MY0 FINAL MONITORING REPORT

BRAHMA SITE

DMS Project No. 100092
Full Delivery Contract No. 7743
DMS RFP No. 16-007571
USACE Action ID No. SAW-2019-00126
DWR Project No. 20190158

Subject: Brahma Stream and Wetland Mitigation Site: As-Built Comment Responses
NC DMS Contract # 7743 RFP # 16-007571 DMS Project No. 100092

Figure 1. Current Conditions Plan View
Tables 4A-G. Stream Visual Stability Assessment
Table 5. Visual Vegetation Assessment
Vegetation Plot Photographs

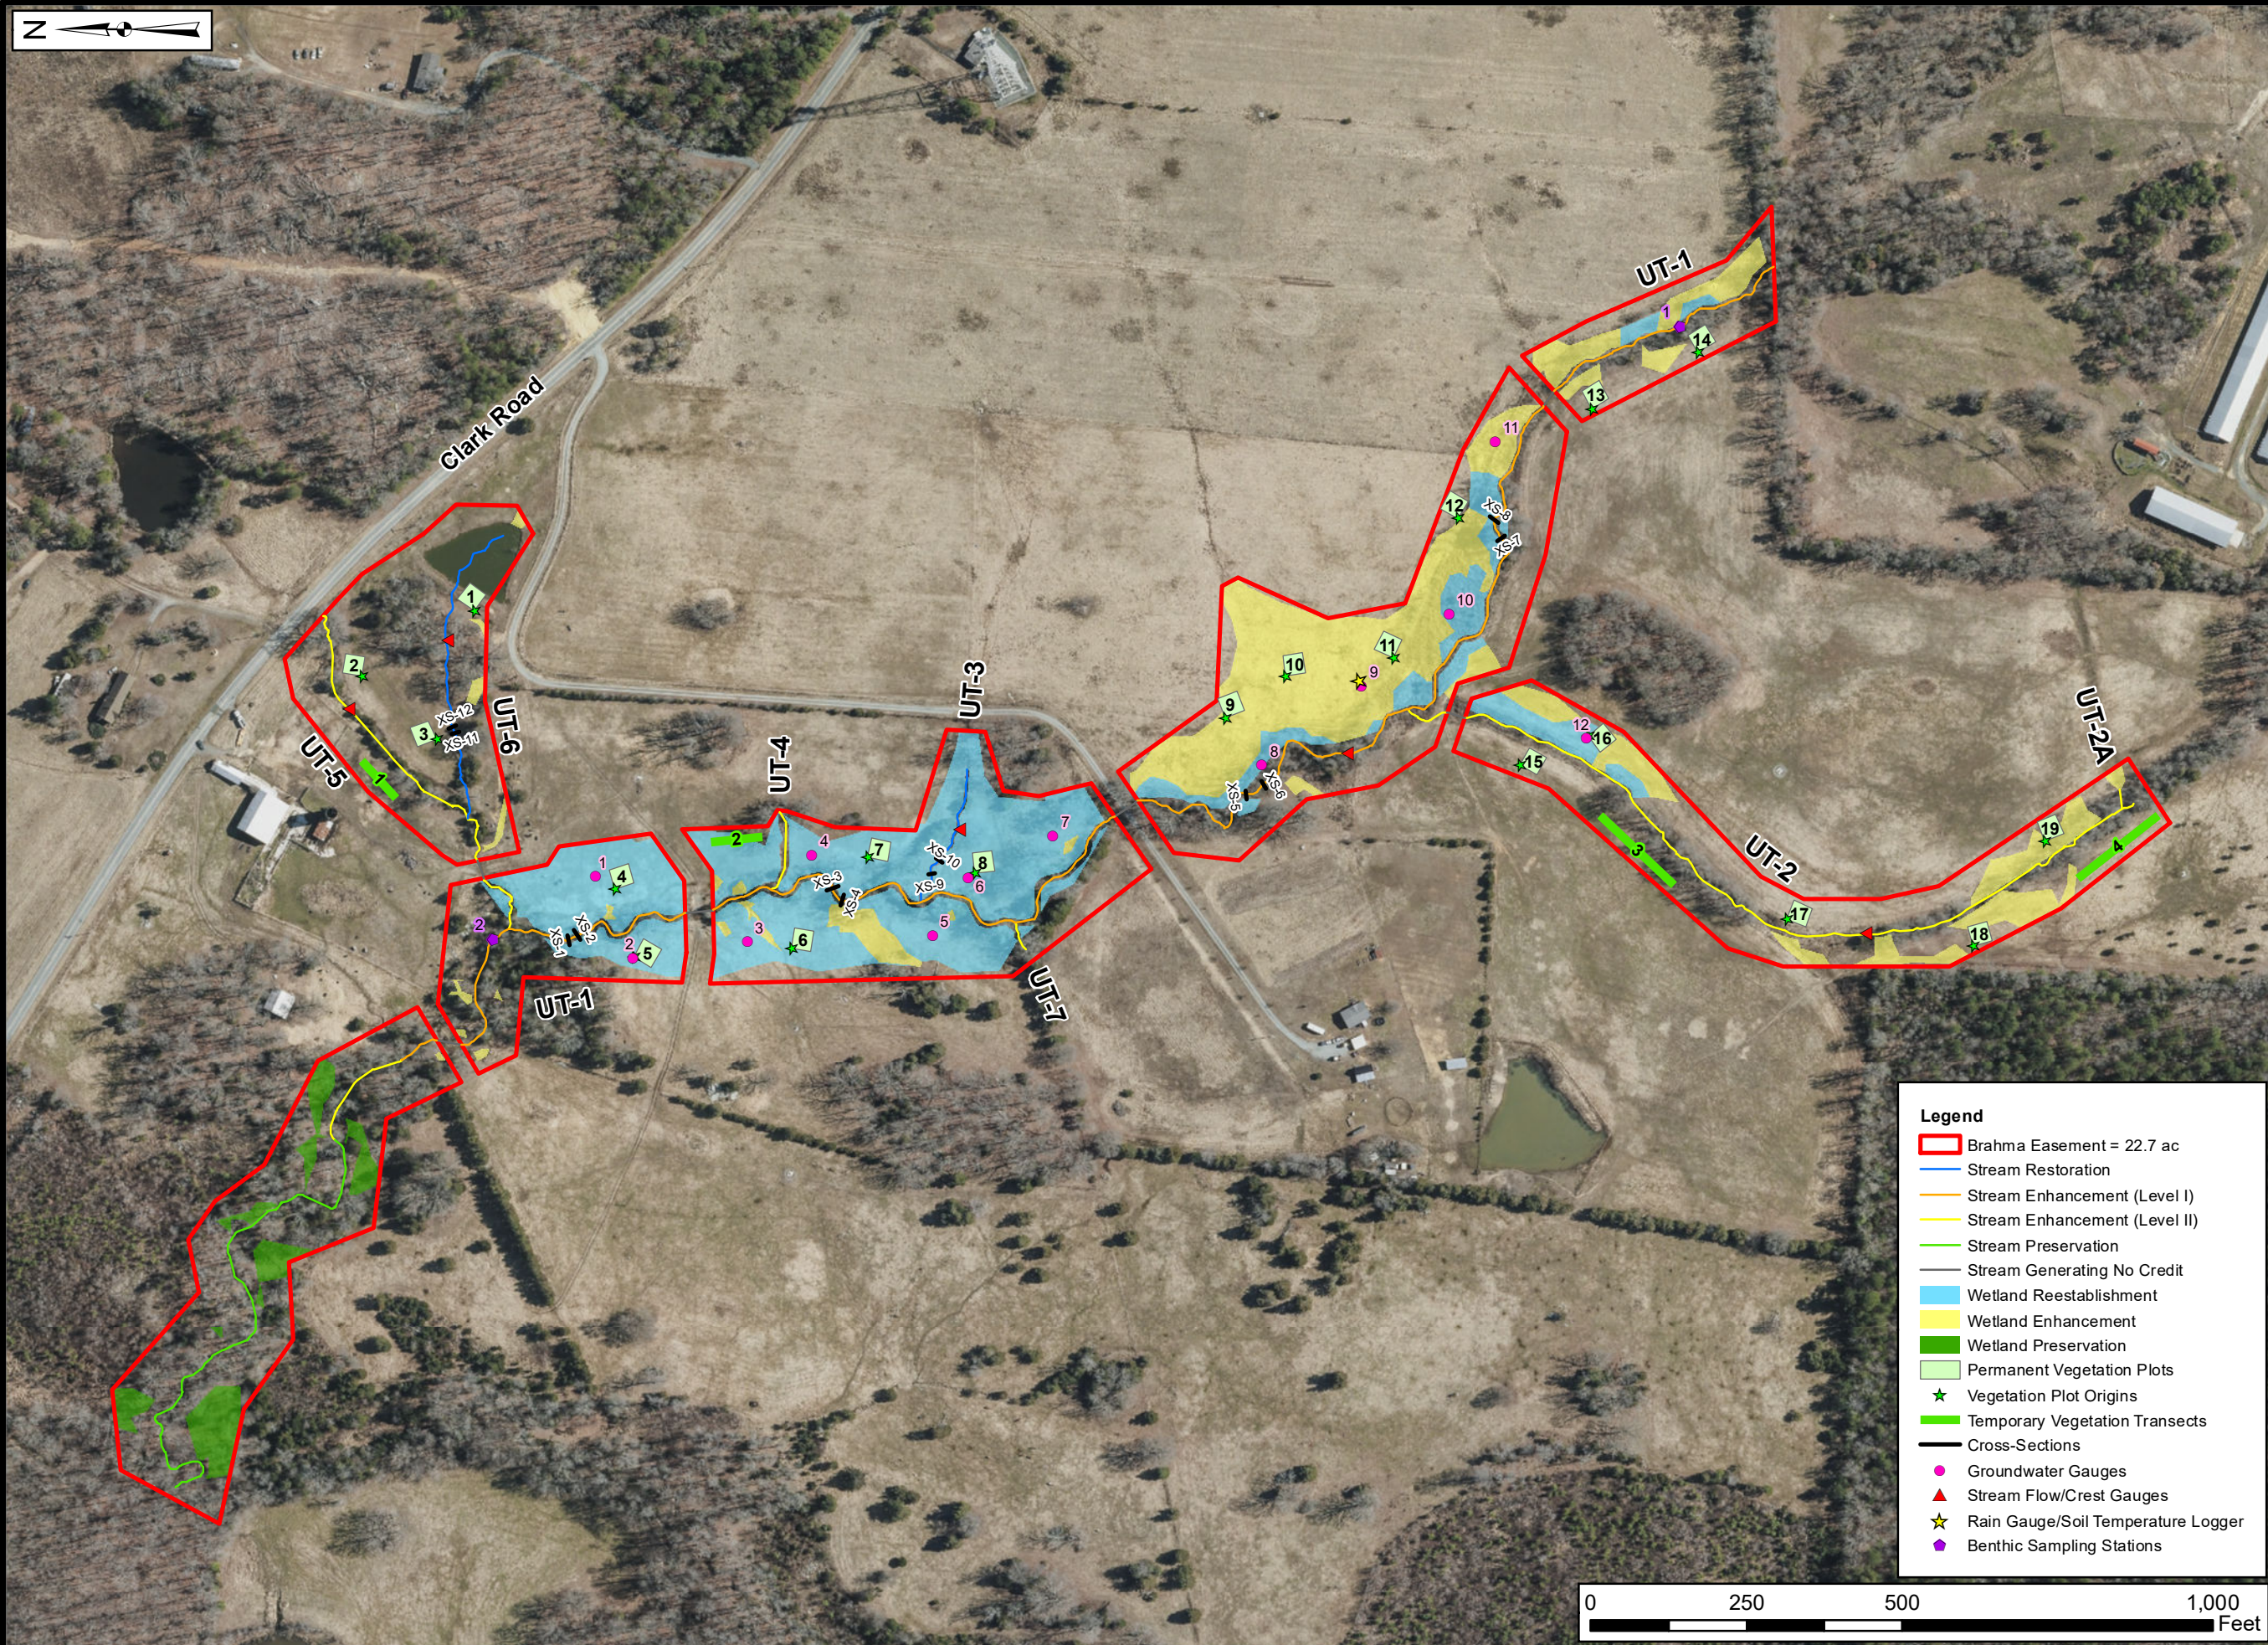
1. Table 1. Check UT2A and UT2. It appears that the lengths may have been swapped/typo.
[This typo was corrected for this submittal.](#)
2. CCPV shows a gray line for 'no credit' stream. Clarify if there are any areas of "no stream credit" on this project.
["No stream credit" areas include crossings at easement breaks.](#)

6. Provide a map or show on CCPV location of benthic sampling. The Mitigation Plan states that location of benthics will be established at the time of pre-construction benthic monitoring.
[Benthic sampling locations were added to the CCPV.](#)

Preconstruction Benthic Results
Preconstruction Benthic Habitat Assessment Data Forms
Figure F-1. Asbuilt Fencing

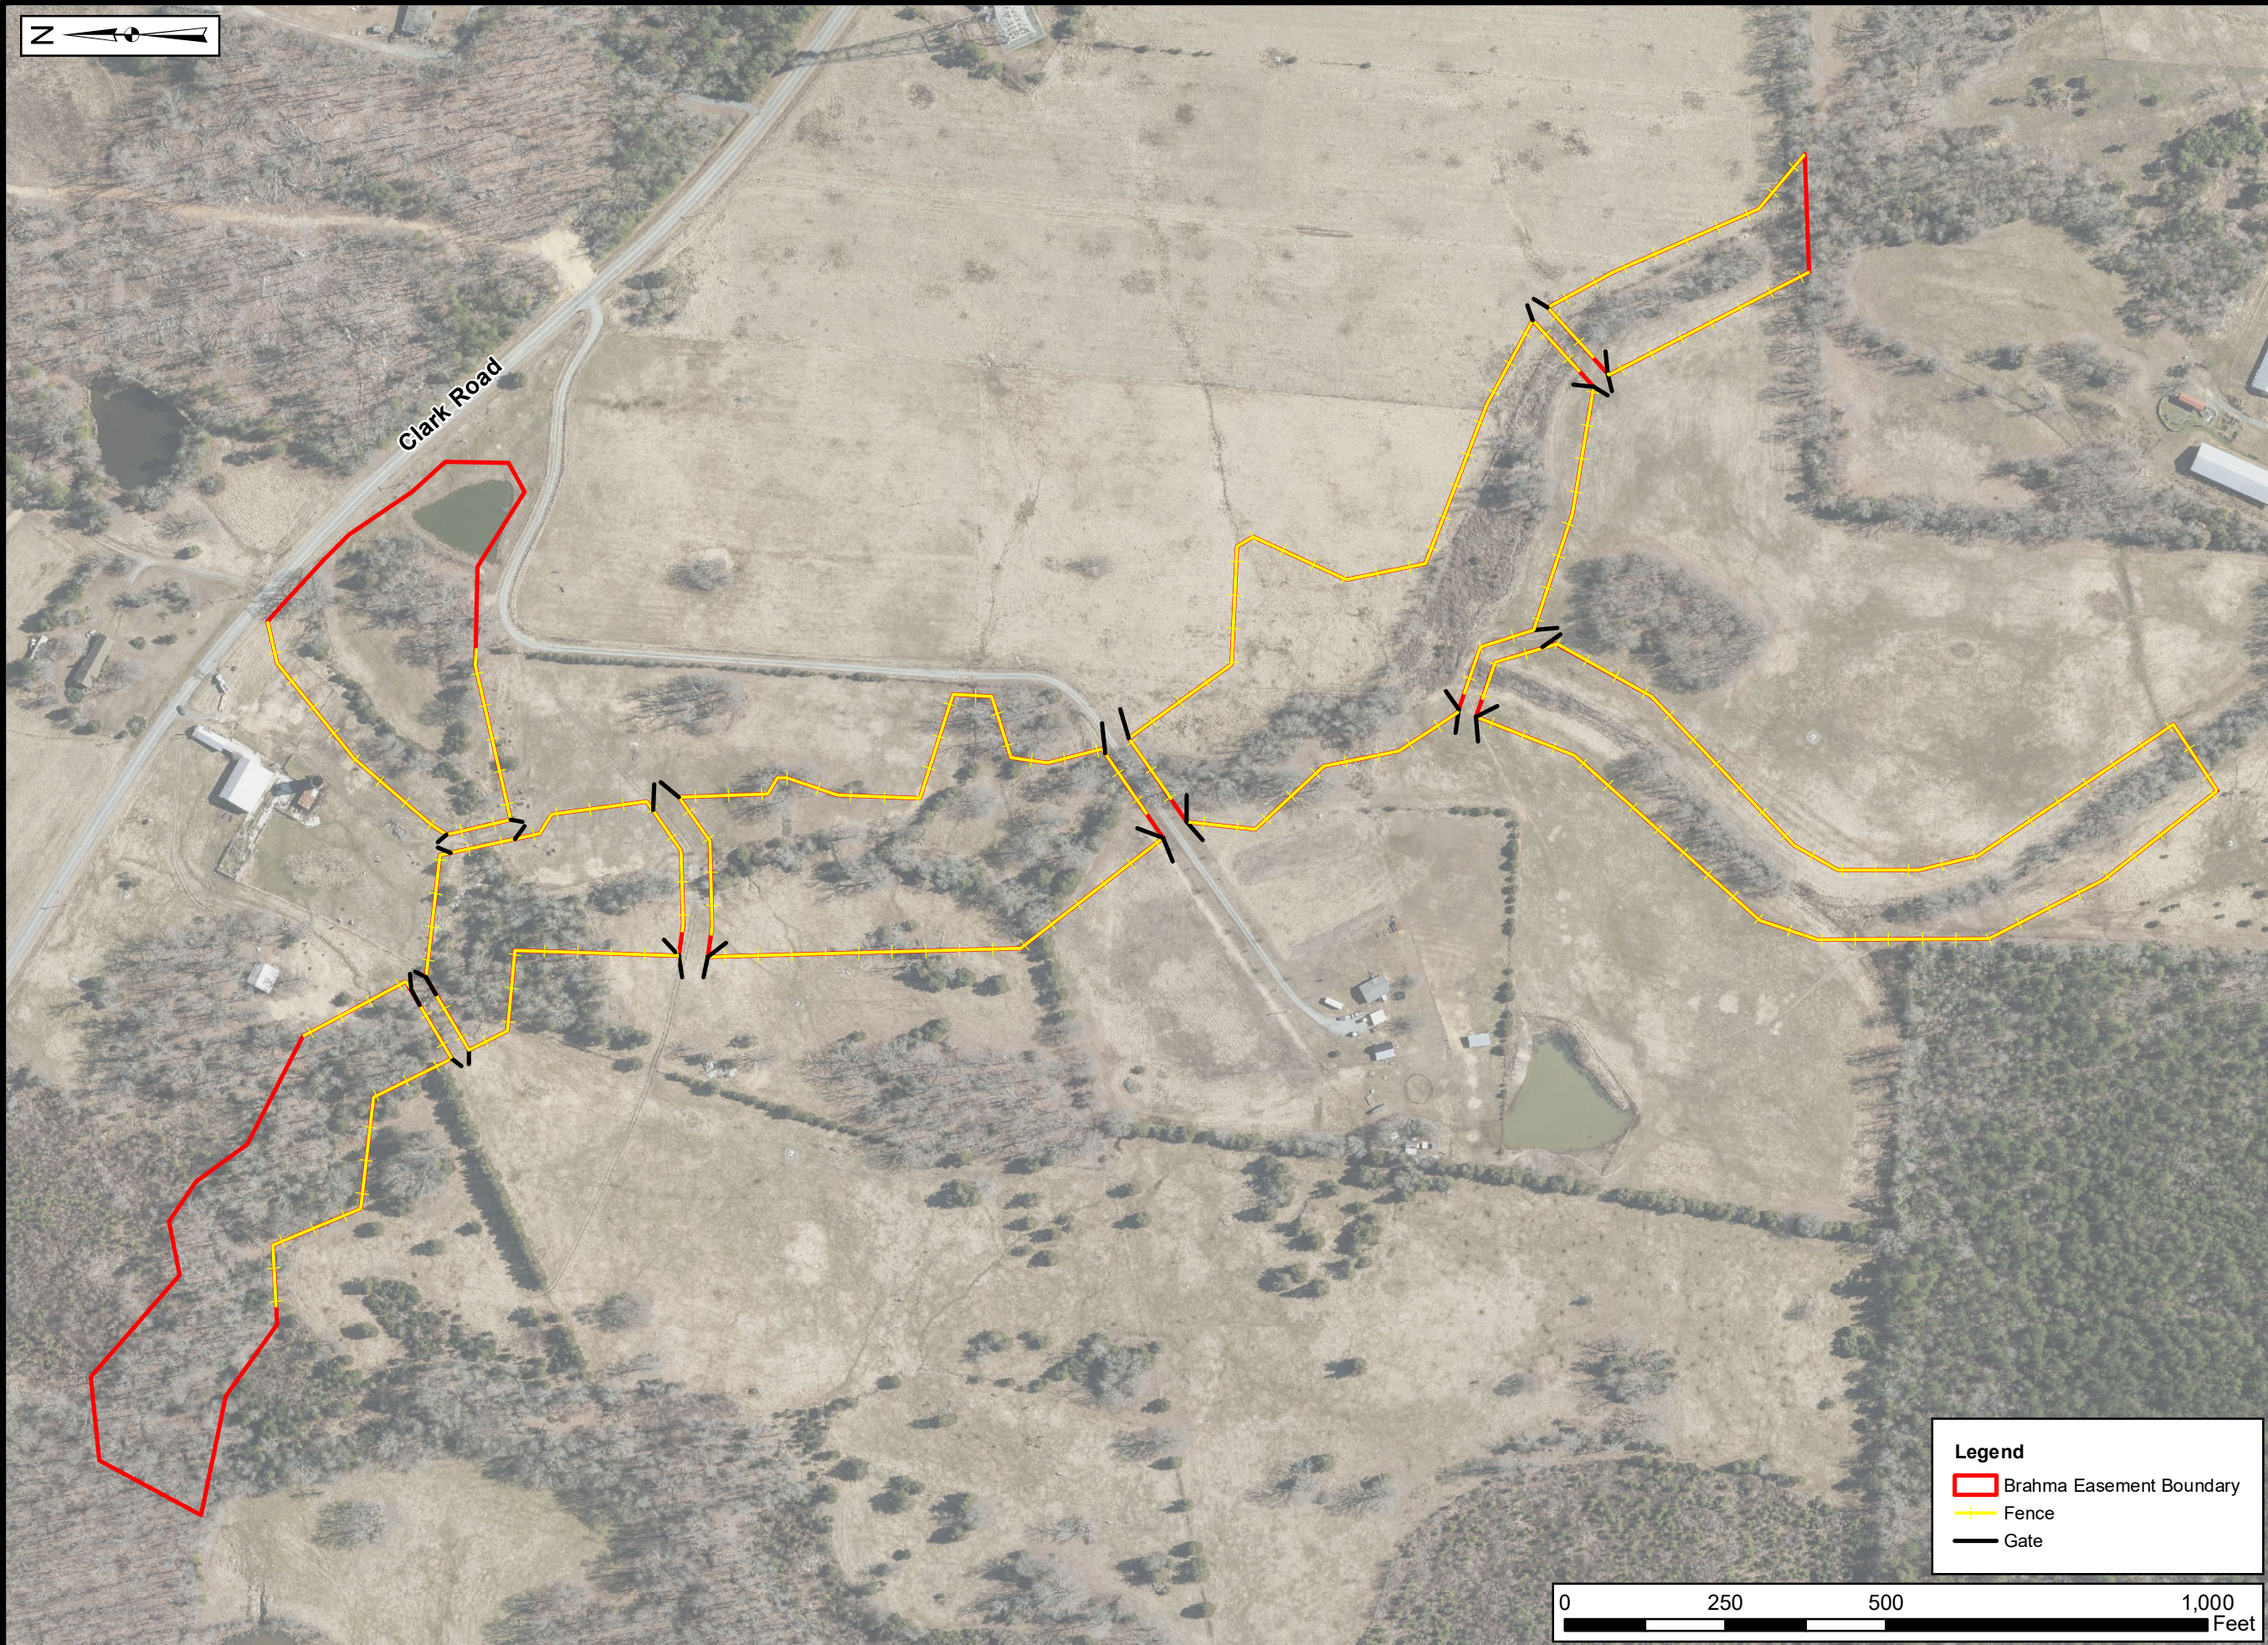
7. There was proposed fencing plan in the construction drawings. Was fencing installed as constructed? If there were changes, please show them in the drawings or add that page into the as-built.
["Figure F-1. Asbuilt Fencing" was added into Appendix F.](#)
